PLANNING COMMISSION MEETING AGENDA

SUBJECT: **Special Land Use Review #1 – AZON Properties/AZON USA, 2130 Ravine Road**

TO: Kalamazoo Charter Township Planning Commission
FROM: Kyle Mucha, AICP – Township Zoning Administrator
 Danielle Bouchard, AICP – Township Planner
SUBJECT: **2130 Ravine Road – Site Plan Review #1**
DATE: February 15, 2024

NEW HEADQUARTERS
BUILDING FOR AZON
Ravine Road Kalamazoo, MI 49004

ELECTRICAL SITE PLAN
 SCALE: 1/8" = 1'-0"

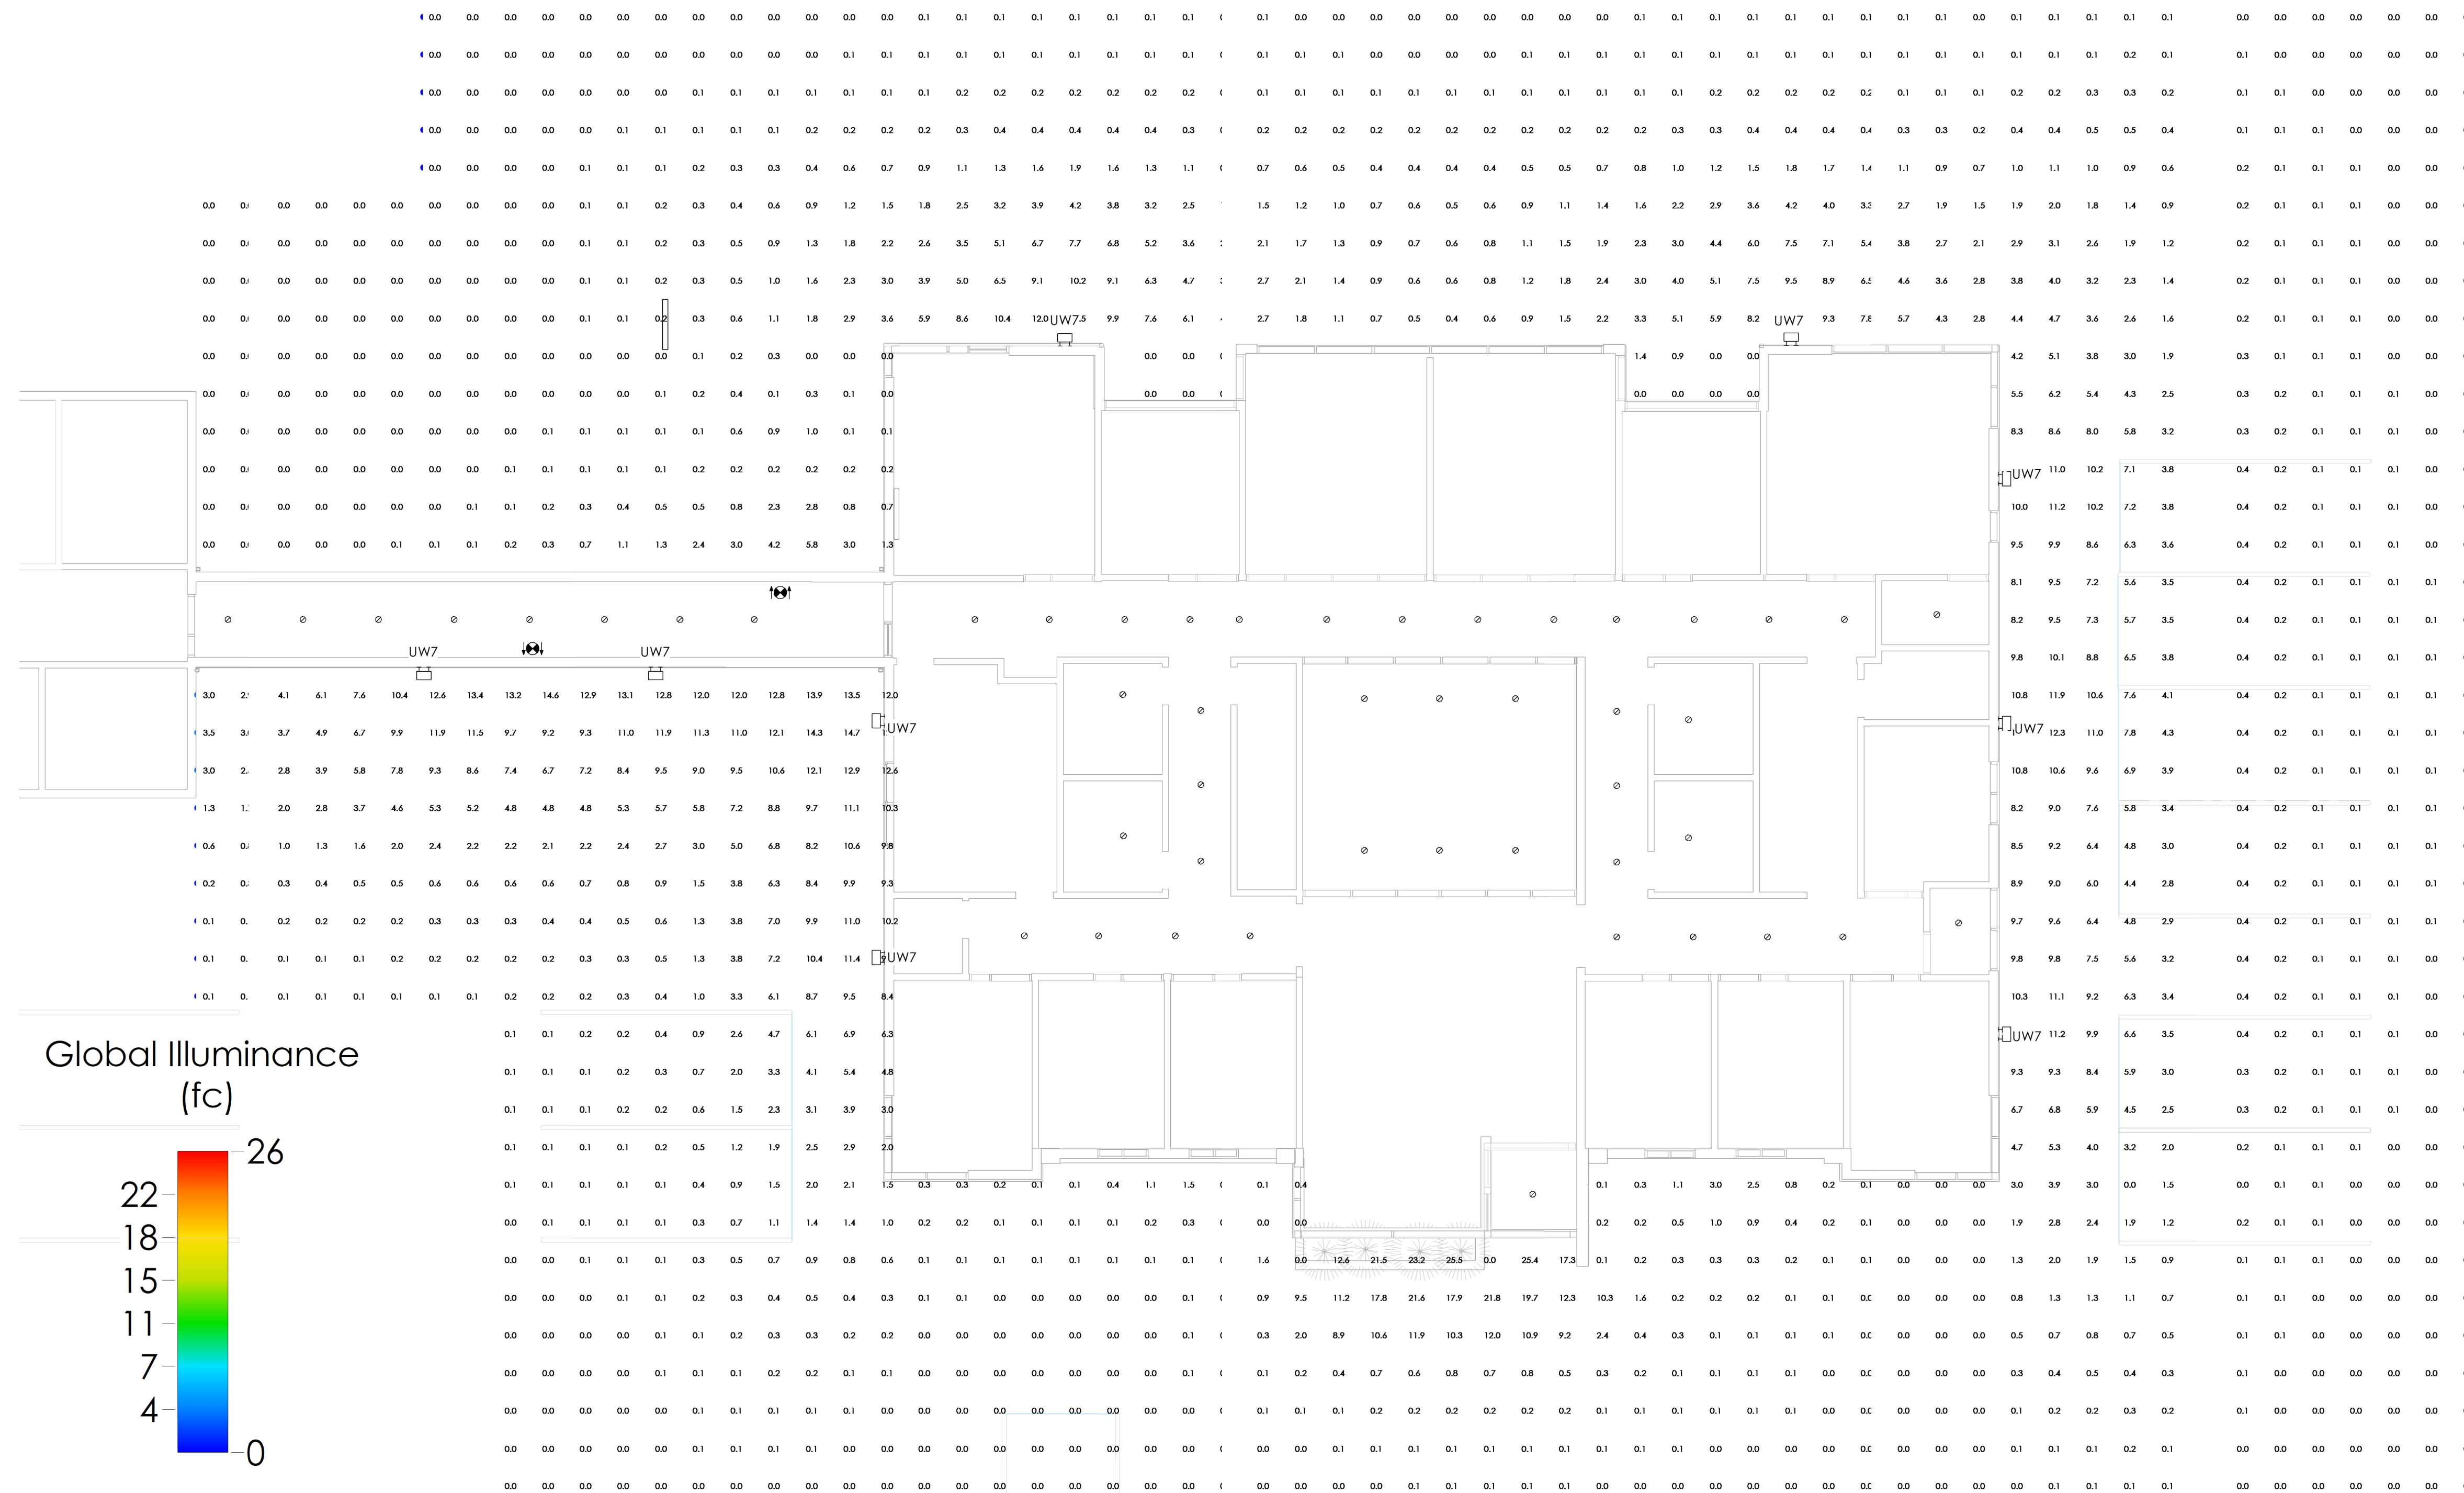
The applicant has provided a photometric (lighting) plan for review by the Township. While the photometric plan shows proposed foot-candle levels, no details have been provided on the type of light fixture nor their mounting height. Further details pertaining to the type of fixtures to be utilized on site is required.
